Panel Report

Mildura Planning Scheme Amendment C95 Deakin Avenue Urban Design Guidelines

21 June 2018

Cathie McRobert, Chair

Figure 2 Extract from Fifteenth & Deakin Structure Plan July 2012 (Source: Council closing submission)

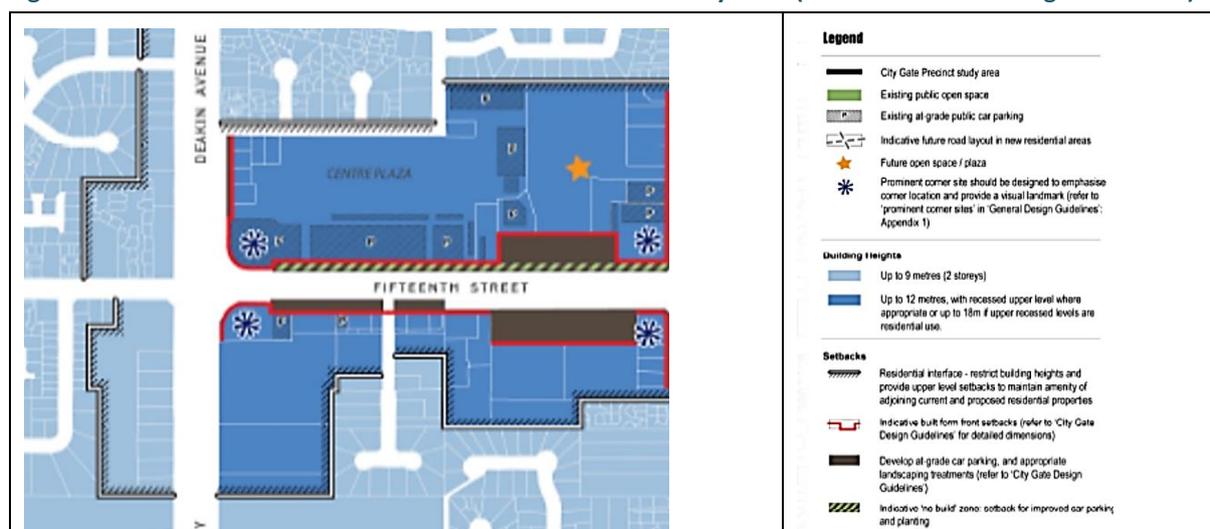
The Panel considers the inconsistency between existing and proposed guidance regarding the location of car parking was overstated by Vicinity and Mr Rogers. By referring to the Structure Plan referred to in DDO12, it becomes apparent there is an aspiration for activation of the centre frontages, with buildings on the City Gate retail core much closer to the street frontages than the existing buildings; and parking between buildings and the street is identified further

to the east along Fifteenth Street, not along Deakin Avenue or near the intersection of Deakin Avenue and Fifteenth Street. The debate that occurred on this issue illustrates a disadvantage of an unduly complex planning framework with multiple sources of guidance, which is exacerbated where understanding a control was dependant on a document that are outside the planning scheme (such as the structure plan).
